UN R13 and Electro Mechanical Brakes

ECE-R13 and Electro Mechanical Brakes (EMB)

Overview of changes made to Informal Document GRVA-09-05

With respect to **GRVA-09-05**, changes were made in the following paragraphs:

Explanation to Paragraph 2.51

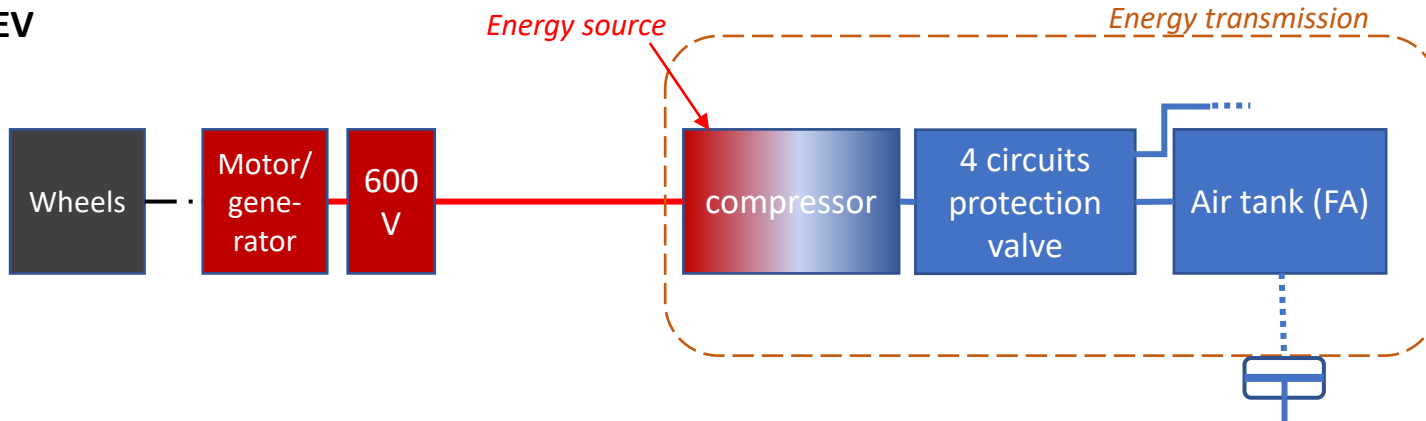
Vehicles with pneumatic braking do have an 'energy source'

2.49. "Energy source" means a device that both generates and provides energy required for the braking system.

Explanation to Paragraph 2.51

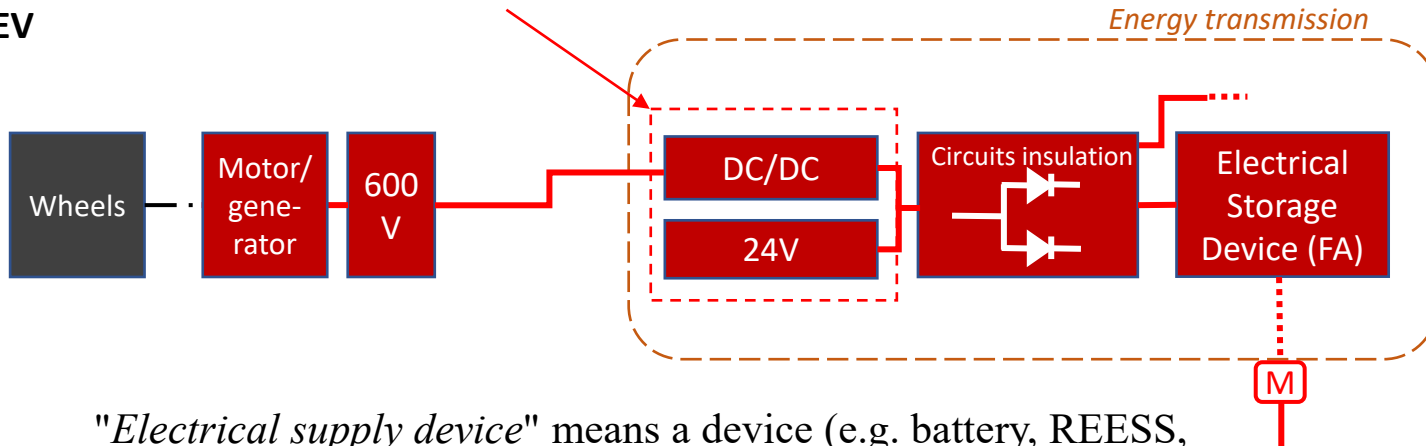
*Vehicles with an EMB can have an 'energy source',
But it is called an 'electrical supply device'*

2.51. "Electrical supply device" means a device (e.g. battery, REESS, DC/DC converter, generator, fuel-cell or a combination of those components) that supplies electrical energy to the braking system's electrical energy storage device(s).

Explanation to Paragraph 2.51

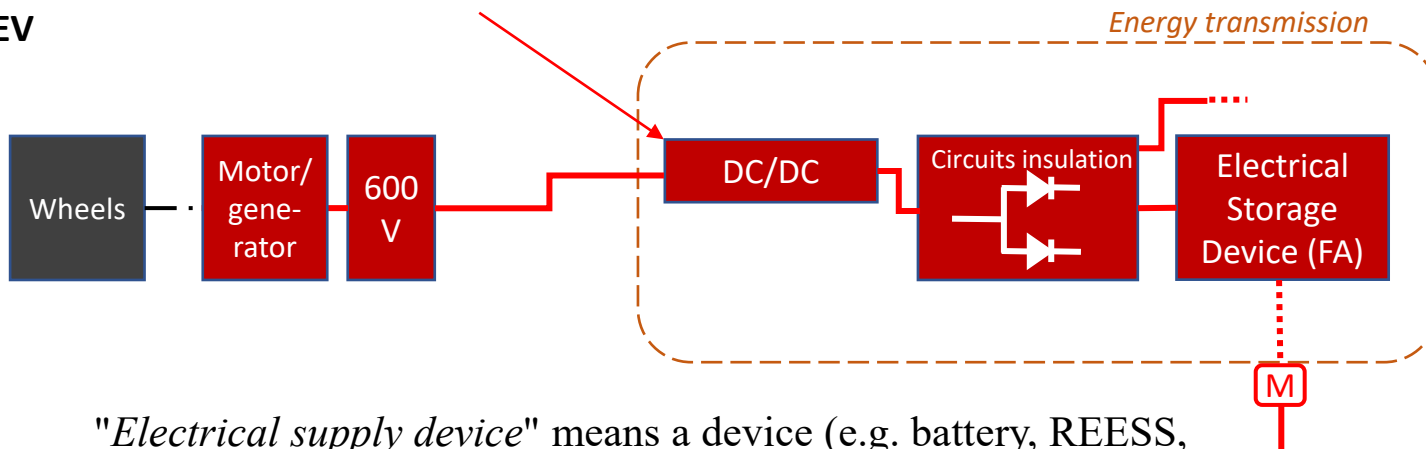
*Vehicles with an EMB can have an 'energy source',
But it is called an 'electrical supply device'*

2.51. "Electrical supply device" means a device (e.g. battery, REESS, DC/DC converter, generator, fuel-cell or a combination of those components) that supplies electrical energy to the braking system's electrical energy storage device(s).
